Economic Commission for Europe**Inland Transport Committee****World Forum for Harmonization of Vehicle Regulations****Working Party on Lighting and Light-Signalling****Seventy-fifth session**

Geneva, 5–8 April 2016

Other Regulations - Regulation No. 112 (Headlamps emitting an asymmetrical passing-beam)**Proposal for Supplement 7 to the 01 series of amendments to Regulation No. 112 (Headlamps emitting an asymmetrical passing-beam)****Submitted by the expert from Poland***

Figure 2
Class B1 luminous intensities test points

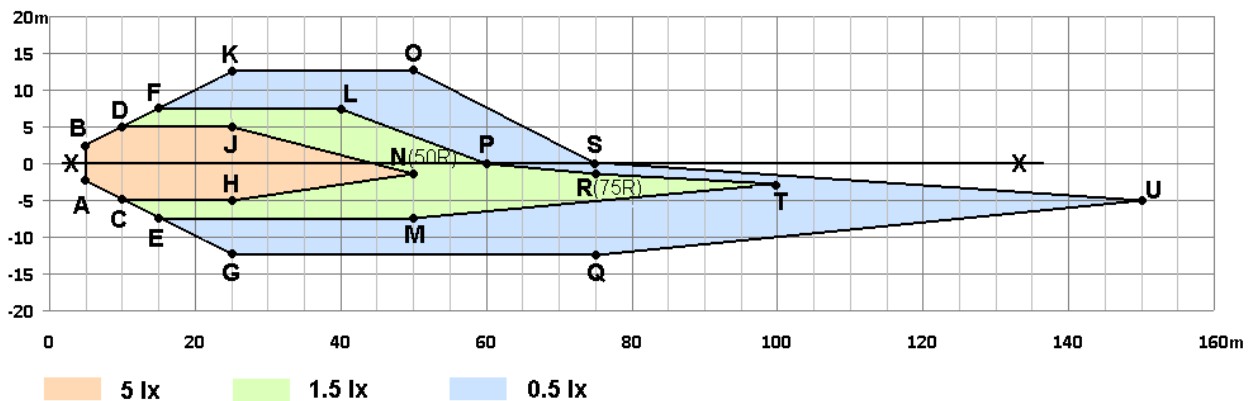
Add a new paragraph 6.2.4.2., to read:

“6.2.4.2. **The passing-beam of Class B1 shall meet the luminous intensities described as follows:**

For right hand traffic, the luminous intensities shall be such that the vertical illumination defined for a direction parallel to a line connecting the headlamp centre and a given point on the road surface will be equal or greater than the values described on Figure 2 and in the tables below.

Note: Vertical illumination at the road surface to be recalculated for luminous intensities for single headlamp. Side: + Left , -Right; 0,0 – headlamp position at 0.75 m above road surface.

<i>Area restricted by points</i>	<i>Minimum required value (lux)</i>
A, C, H, N, J, D, B, A	5.0
C, E, M, T, R, P, L, F, D, J, N, H, C	1.5
E, G, Q, U, S, O, K, F, L, P, R, T, M, E	0.5

At any point and area, the value of 50 lux shall not be exceeded.

For left hand traffic, all points and values should be mirrored with respect to the X-X line.
